Nuclear and Industrial Safety Agency

On the Implementation of Measures Filling the Primary Containment Vessel up to the Top of Active Fuel in Fukushima Dai-ichi Nuclear Power Station

On the Implementation of Measures Filling the Primary
Containment Vessel up to the Top of Active Fuel in Fukushima
Dai-ichi Nuclear Power Station

Primary Containment Vessel of Unit 1 in Fukushima Dai-ichi NPS
Schematic Diagram

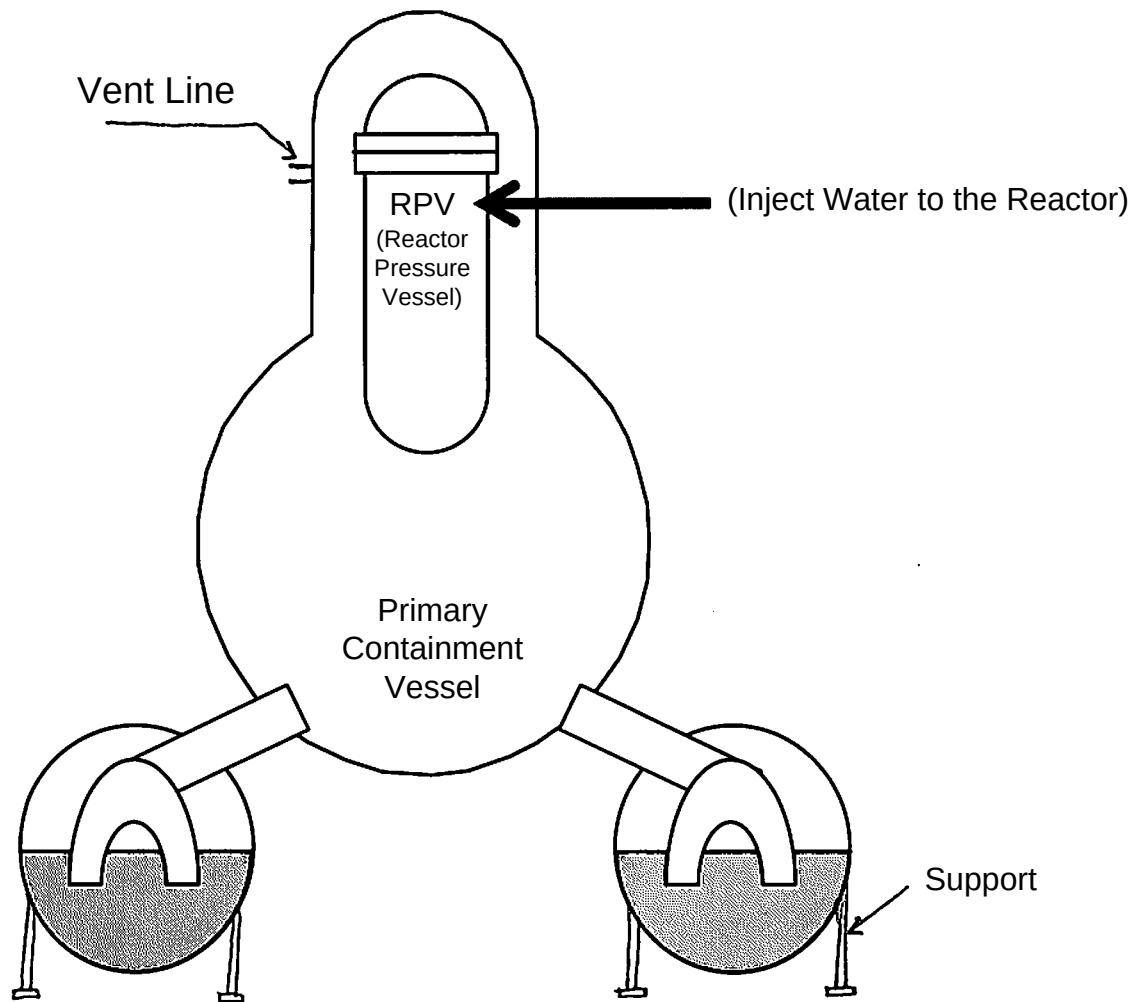
NISA confirmed the following points and determined TEPCO's evaluations were reasonable. As an aside, regarding the support columns of the suppression chamber, from the viewpoint of low tolerance with respect to the acceptable criteria values, in the future, in addition to undertaking improvements for the operational environment within the reactor buildings, NISA considers conducting seismic reinforcements to be desirable, as well.

- Are the computed values for the stress evaluation points the below acceptable criteria values?
Regarding the dry wells, suppression chambers, and the supporting columns, the computed value for the stress arising from the external supporting column, which was the most strictly evaluated portion, was 0.923 times the acceptable criteria values, but all the acceptable criteria values were met, and regarding the bellows, NISA confirmed the FEM analysis (elasticity analysis) considering the broad-range evaluation of the horizontal change of position was computed to be 26.3mm, and the amount of change in position of the design (46.32mm) was enveloped.

- ① Part of the reactor core that did not come into contact with water should be exposed to water, and the rate of occurrence for steam will rise;
- ② The sites of leakage for the PCV should be submerged to lower the leakage rate; and
- ③ The capacity of the gas inside the PCV should be reduced accompanied by the rising water level inside the PCV

- Regarding the water level inside the PCV and the leakage from the PCV, in addition to carefully monitoring the process, TEPCO will implement appropriate response measures determined in advance such as controlling the injection amount, etc.
- Regarding the support columns of the suppression chamber, which have little leeway with respect to acceptable criteria values, from the presumption that aftershocks will continue to arise from now on, TEPCO will review how to further strengthen the seismic resistance of the NPS and make improvements for its operational environment.
